ADDENDUM NO. 2

Date: March 23, 2023

Issued by: Sacramento City Unified School District

**Project: Project #: 0525-462
John F. Kennedy Parking Lot**

C1.4

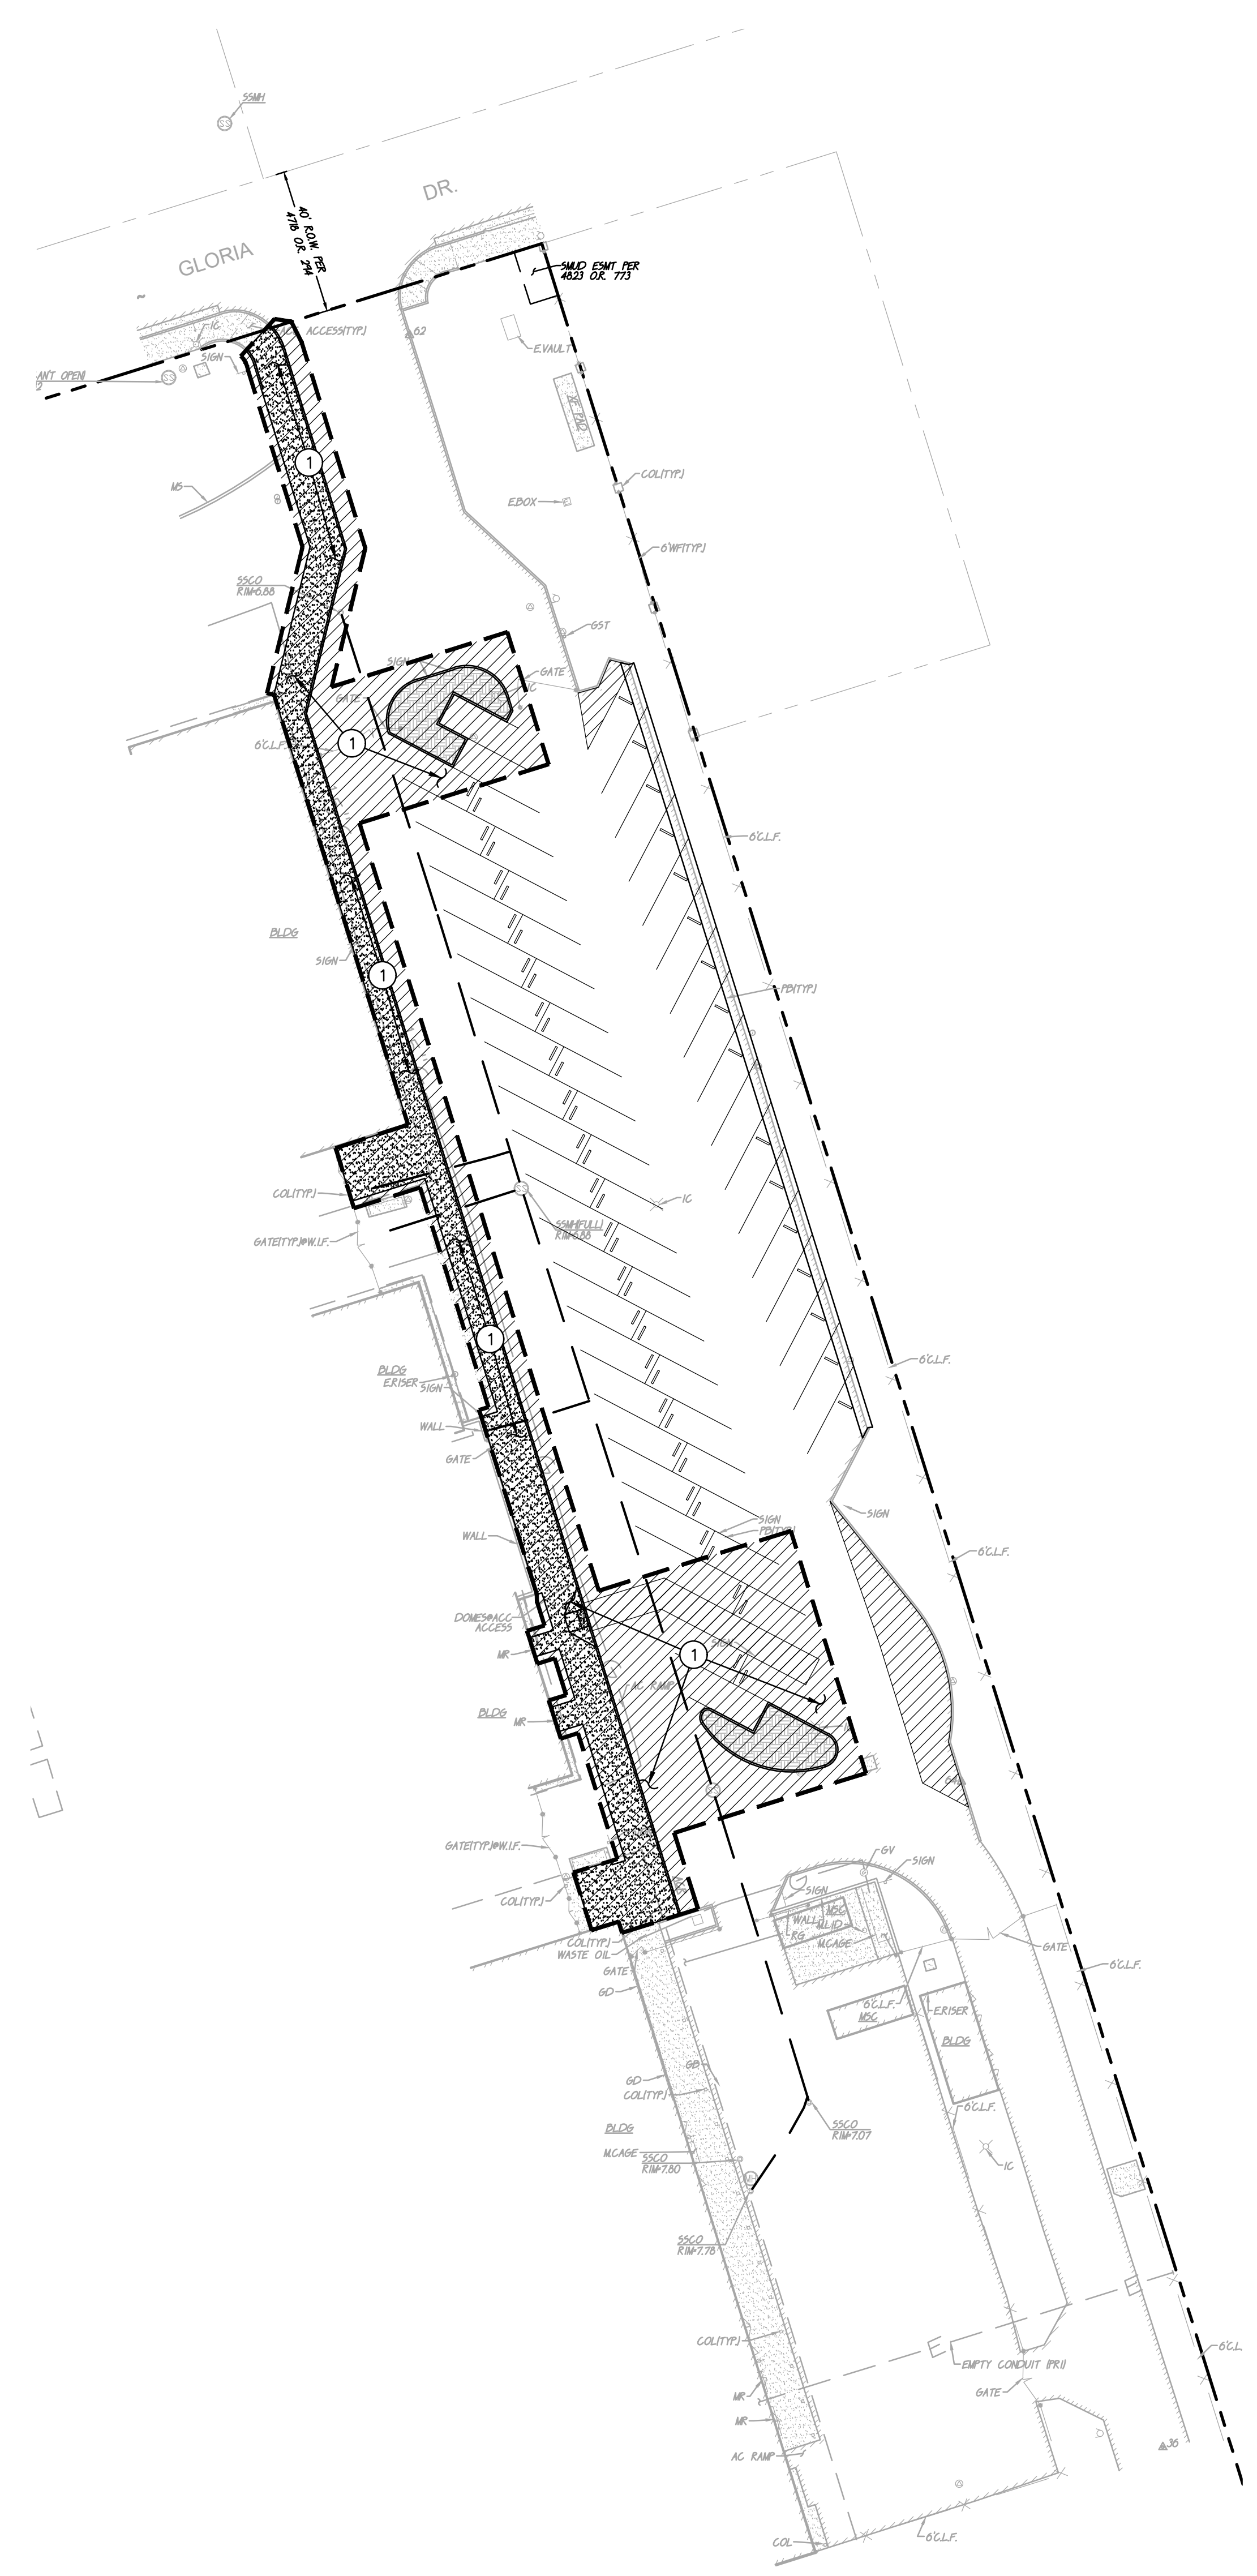
- E. Lime treatment is not required in the staff parking lot an alternative subgrade preparation option has been added to plans. See addendum#2.
- F. Where AC paving is noted to have 1.8 percent max are the section of AC paving where the max slope is expected.

LIME TREATMENT ALTERNATIVE

AS AN ALTERNATIVE TO THE LIME TREATED SOIL SUBGRADE SECTION THE CONTRACTOR IS TO PROVIDE 12" OF CLASS II AB COMPACTED TO 95 PERCENT OF THE MAXIMUM DRY DENSITY PER ASTM D1557 PLACED OVER TENSAR BX1100 GEOGRID
